CITY OF ARLINGTON PRAIRIE CREEK DRAINAGE IMPROVEMENTS PHASE 2A CONSTRUCTION - PROJECT NO. P02.371

AS BUILT

SHEET
 C-3
 5 of 15

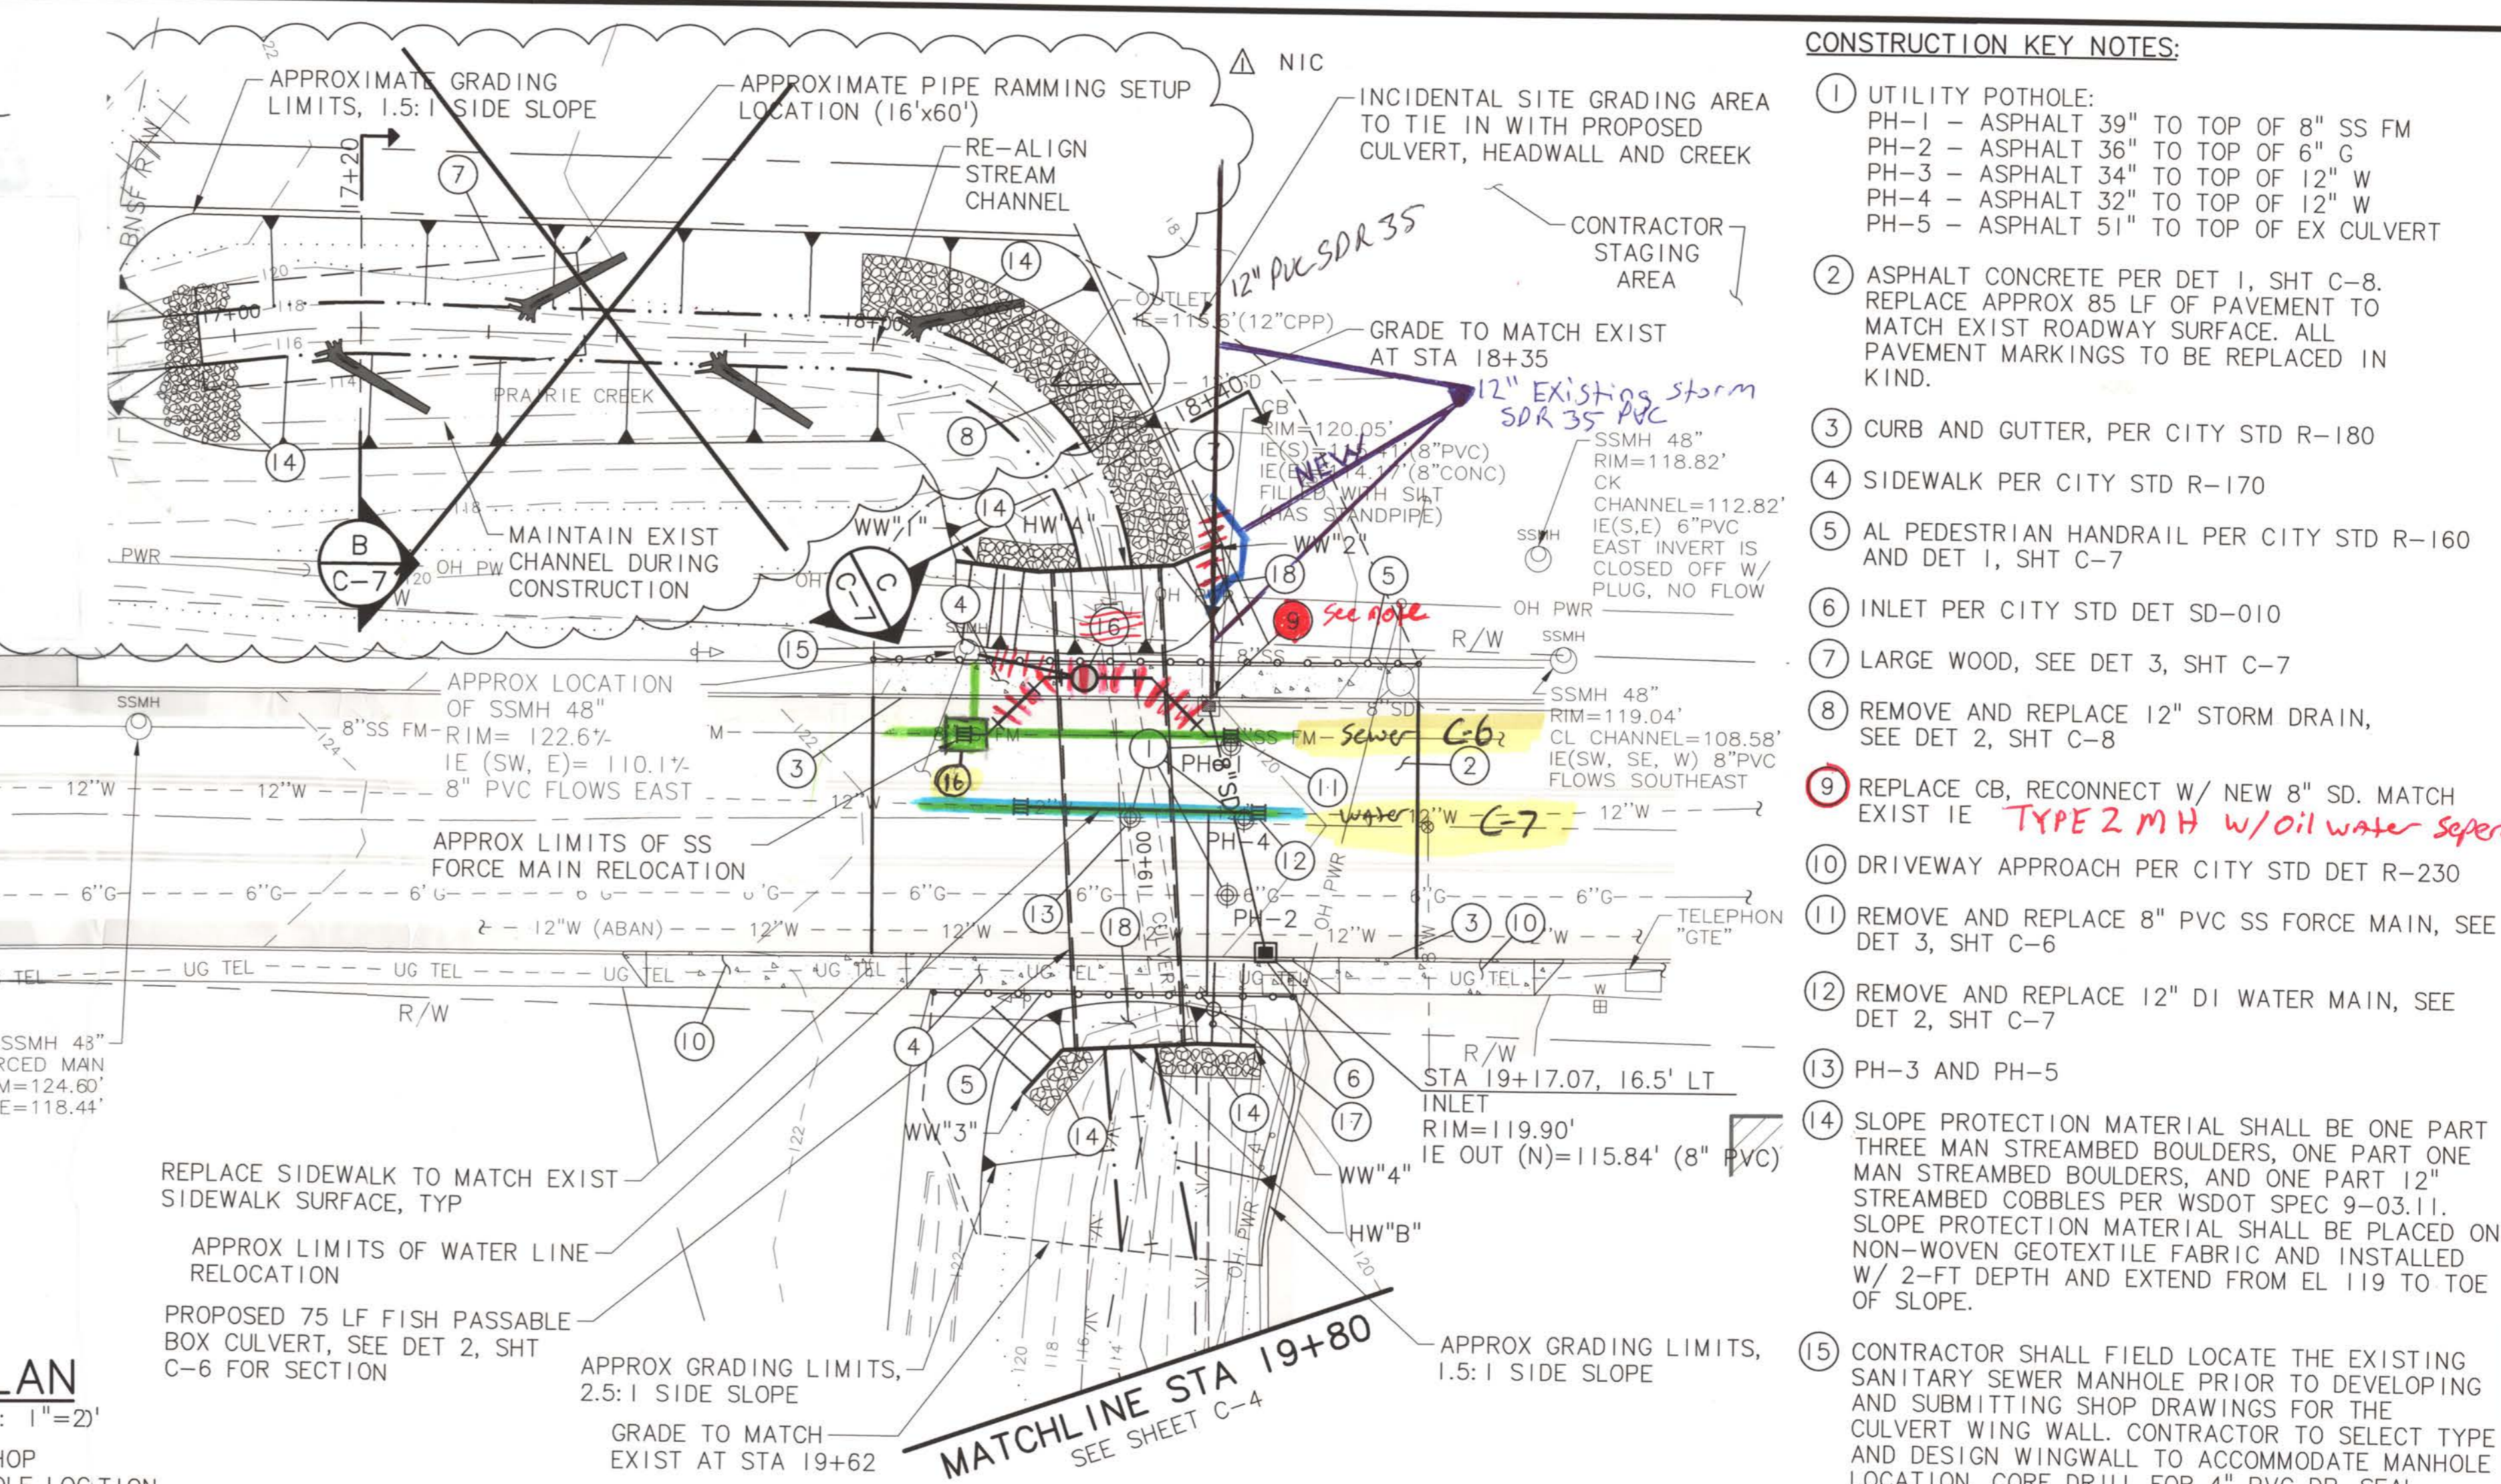
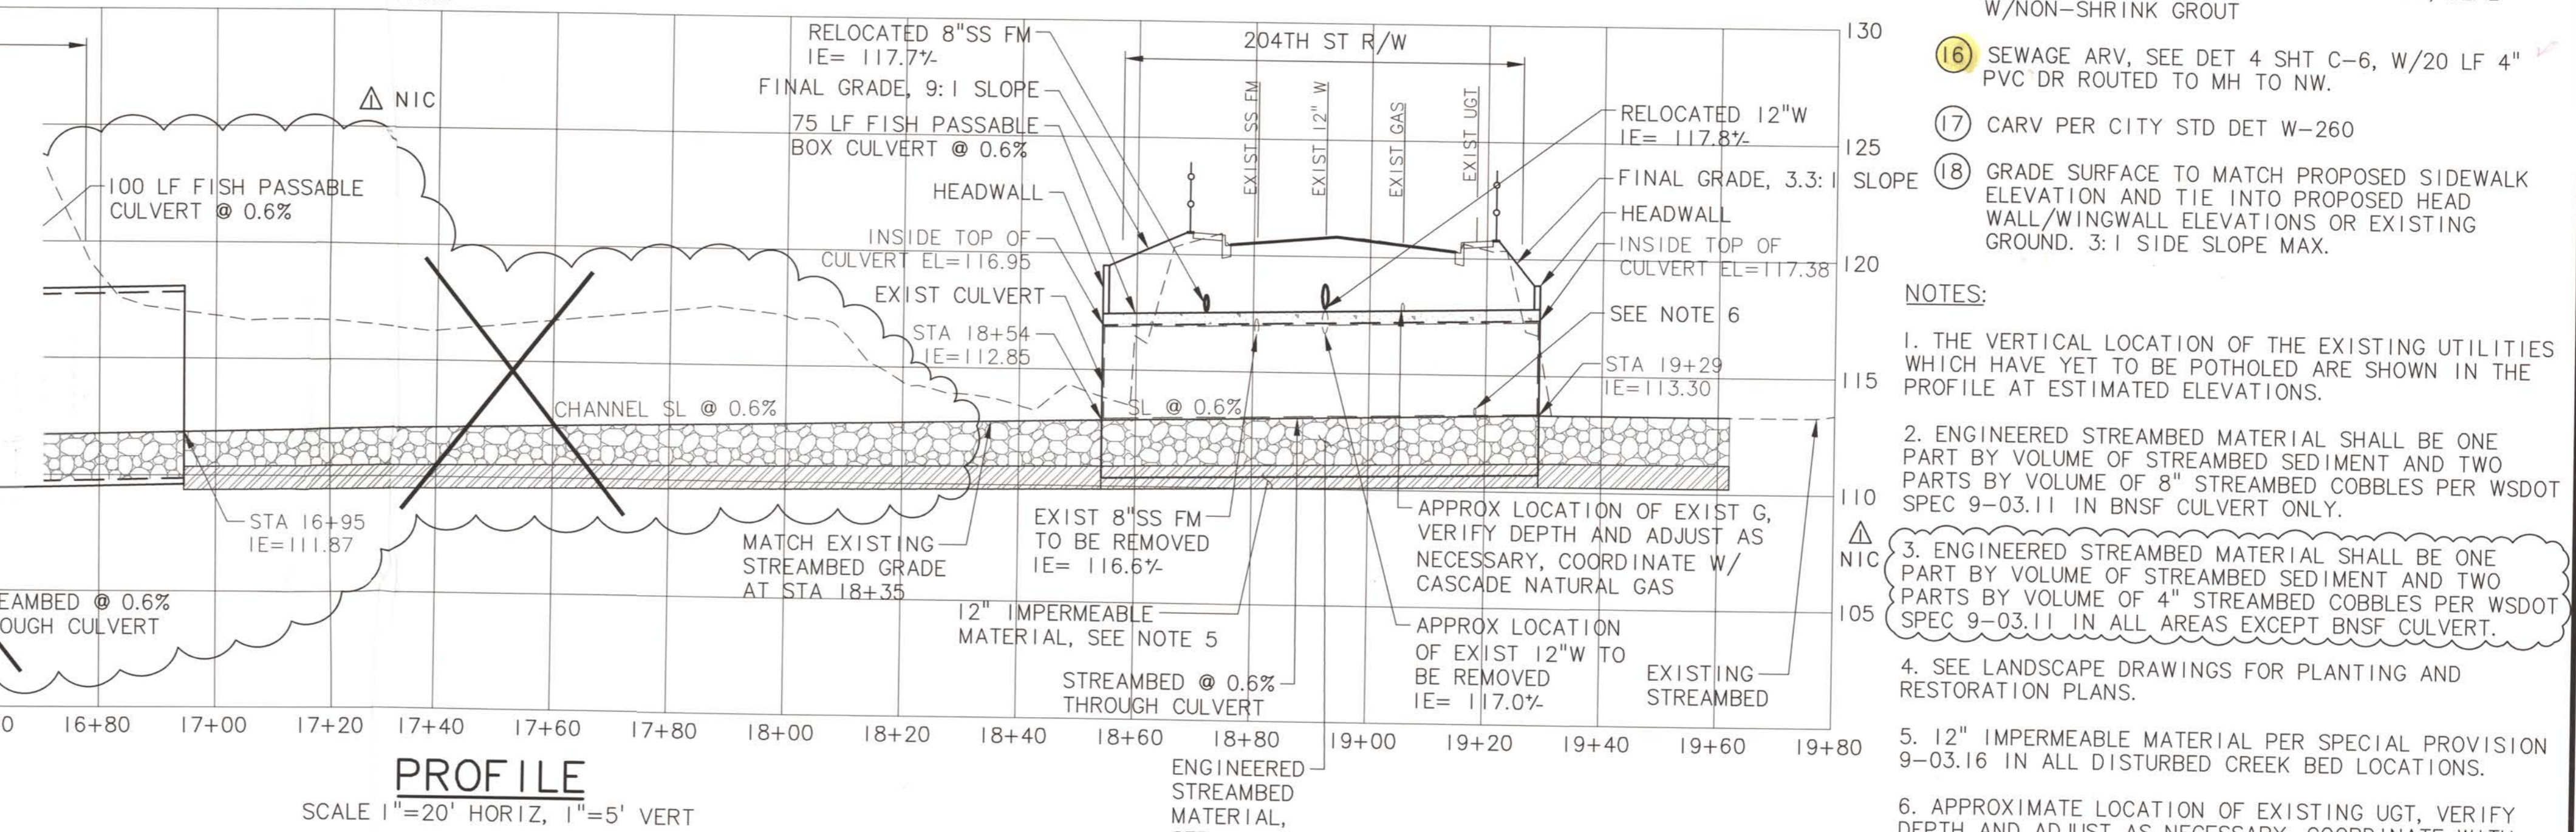
- REMOVE AND REPLACE 12" STORM DRAIN, SEE DET 2, SHT C-8
 - REPLACE CB, RECONNECT W/ NEW 8" SD. MATCH EXIST IE **TYPE 2 MH w/oil water separator**
 - DRIVEWAY APPROACH PER CITY STD DET R-230

- Based on our field investigation this morning, the Catch Basin (CB) identified in Construction Key Note 2 on sheet C-3 is a water quality structure; a manhole with a vertical pipe and an inlet lid. The construction drawings show this CB is to be removed and reset. You stated that you were able to install the culvert with this structure in place, as such, do not remove or reset this structure. Connect the 8" SD from the south and reconnect the SD pipe discharging to the north.
